PPL Bell Bend Nuclear Power Plant

401 Water Quality Supplement

BINDER 4
Correspondence
Item 39

Re: Notice of Application Review for PPL Bell Bend, LLC;
Bell Bend Nuclear Power Plant, BNP-2009-073;
Salem Township, Luzerne County, Pennsylvania

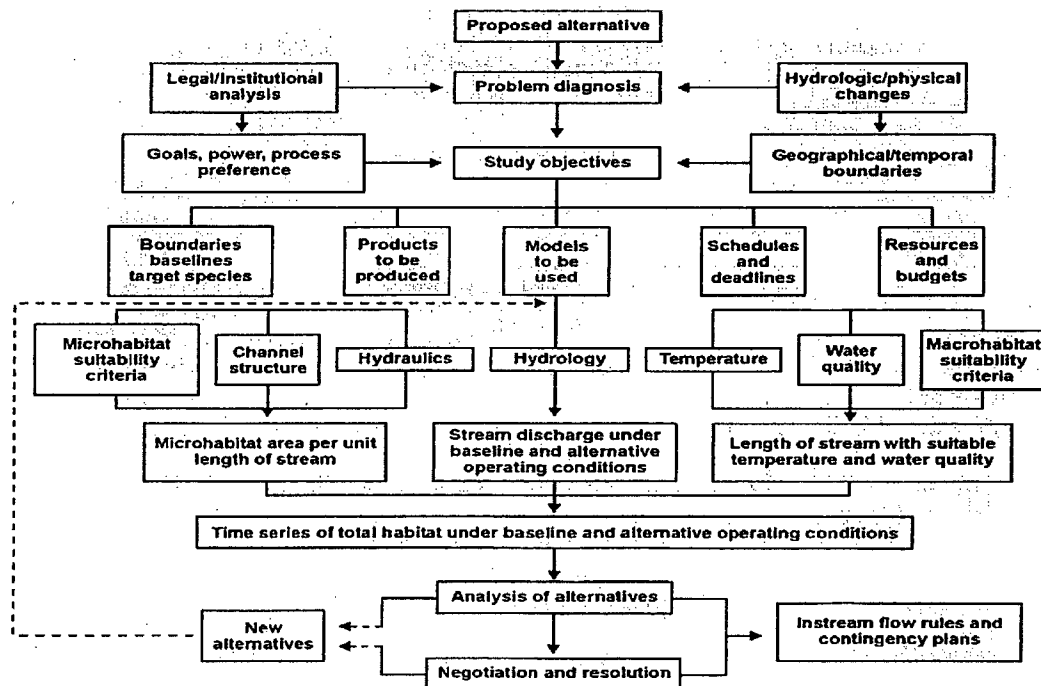
4. *Figure 2-1 depicting the "Generalized IFIM sequence" does not show steps for consultation with stakeholders to determine goals of the study, and does not include a step for stakeholders to reach a consensus regarding study conclusions. Due to time constraints and the way the IFIM study was conducted, some of the consultative steps were skipped and had to be retrofitted. In any case, the steps are essential to producing a viable IFIM study and should be included on Figure 2-1.*

The flow chart contained in Figure 2-1 is actually a flow chart of the habitat model development within the IFIM process. This figure was not intended to illustrate a broader consultation process. The IFIM process is implemented in five sequential phases: problem identification, study planning, study implementation, alternatives analysis, and problem resolution (see figure below).¹ A more complete description of the IFIM process will be included in the amended report to be provided shortly.
